4.18 STEAM GENERATOR TUBING SURVEILLANCE

ATTACHMENT 2

SIGNIFICANT HAZARDS CONSIDERATION (SHC) DETERMINATION

This change request includes the following changes to ANO-1 Technical Specifications 4.18 pertaining to Steam Generator Tubing Surveillance.

FIGURE 4.18.1

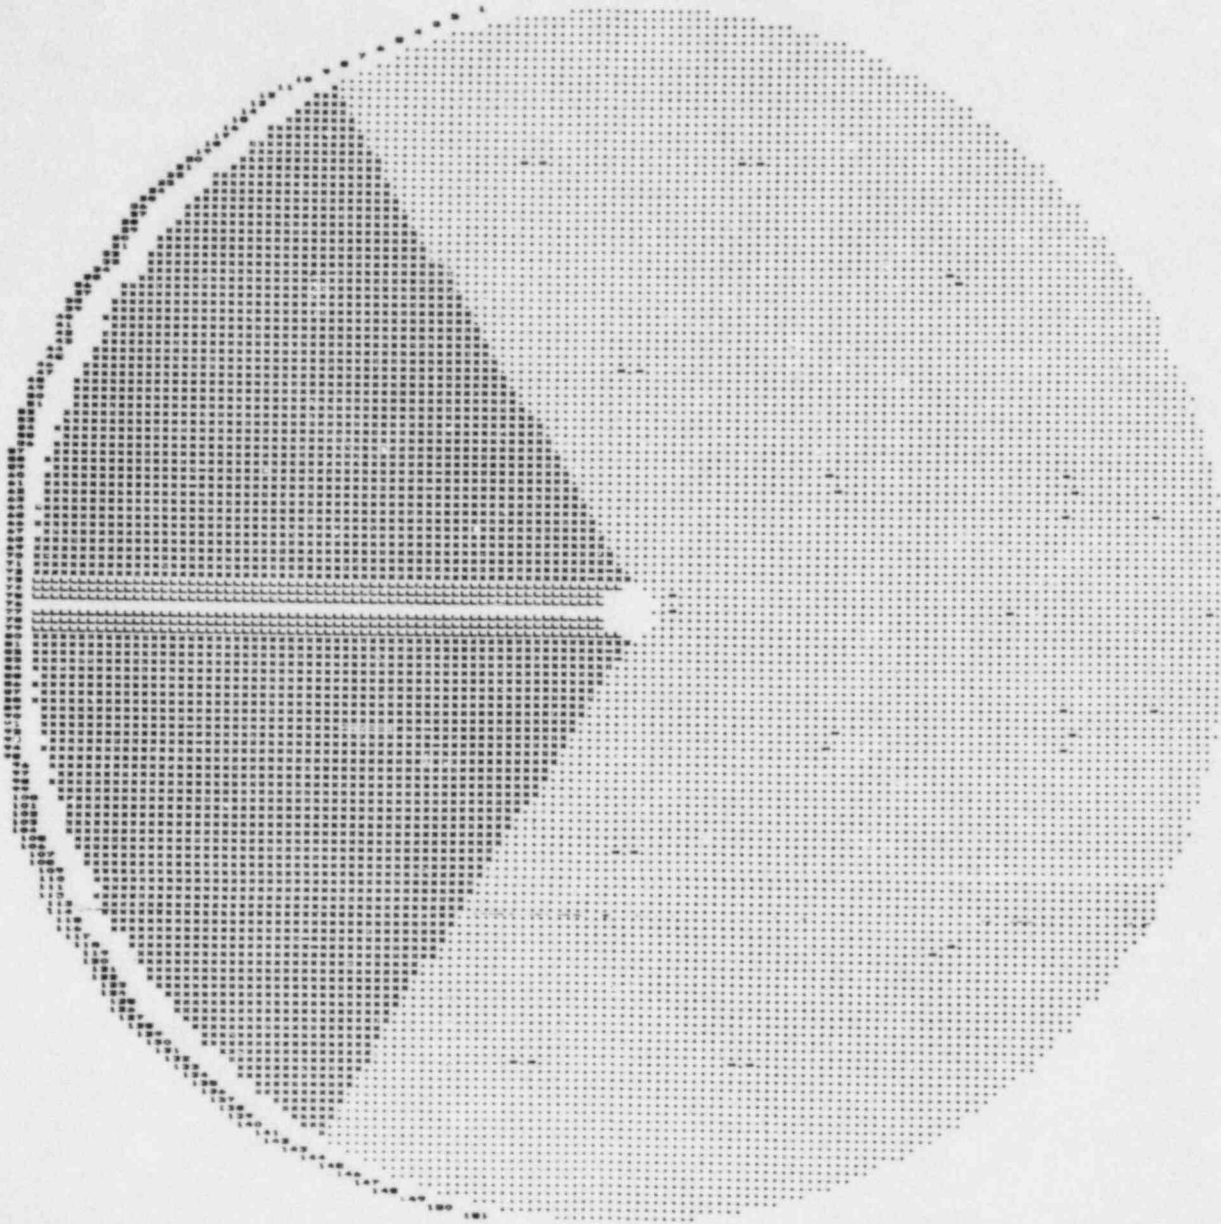
- d. Technical Specification 4.8.3.a.3(3): A new special group A-3 is added. The new group is defined by a new Figure 4.18.1.

The new special group consists of 4,831 tubes adjacent to group A-1, the lane region. The new group is a large wedge (~1/3 of the tube bundle) originating at the center of the bundle fanning out on either side of the lane region. This new special group is selected due to tube degradation noted in recent steam generator tubing inservice inspections and recent leaker outage tube inspections. Sample analyses performed on tubes pulled during recent inspections have shown that intergranular attack (IGA) is the root cause of tube degradation leading to the plugging of ~280 tubes in the OTSGs. This attack has been concentrated in an around the lane region, group A-1, and at the periphery of the tube bundle near the lane. The proposed group A-2 more than adequately bounds the region of degraded tubing found to date.

Prior to the 11/82 (1R5) outage 26 tubes had been plugged due to service related defects/indications. All 26 tubes were in the A-OTSG (no defects had been recorded in the B-OTSG prior to the 11/82 outage). Twenty two of these defects were located at the upper tubesheet (UTS) secondary face or within the upper tubesheet (UTSM). All twenty two of these defects would have fallen into this new A-3 special group.

The 100% eddy current examination performed during the 11/82 (1R5) refueling outage identified 83 tubes with pluggable defects in the A-OTSG and 45 tubes with pluggable defects in the B-OTSG. The majority of these defects were located in the UTSM (69 tubes with UTSM defects in A-OTSG and 34 tubes with UTSM defects in B-OTSG).

The UTSM defects in both the A&B-OTSG's were located predominantly in a quadrant around the open lane. Defects below the UTS were scattered randomly over the entire tube bundle. Of these defective tubes, 66 in the A-OTSG and 29 in the B-OTSG would have been detected while conducting a special inspection of the new A-3 group from the 15th TSP up. The defects in the remainder of the tubes located within the bounds of the special group (4 in the A-OTSG and 4 in the B-OTSG) were randomly dispersed below the 15th TSP.

The results of the March 1984 mid-cycle outage also supports the proposed configuration of the new A-3 group. During the mid-cycle inspection, an examination identical to that proposed by the new special A-3 group was conducted. The defective and degraded indications identified during this inspection (excluding those tubes with previously reportable indication) all fell well within the bounds of the large wedge defined by Figure 4.18.1. The heaviest concentration of degraded tubes were found within 10 rows of the lane and around the periphery either side of the lane.

(3) Group A-3: Tubes in the wedge-shaped group on either side of the lane region (Group A-1) as defined by Figure 4.18.1.
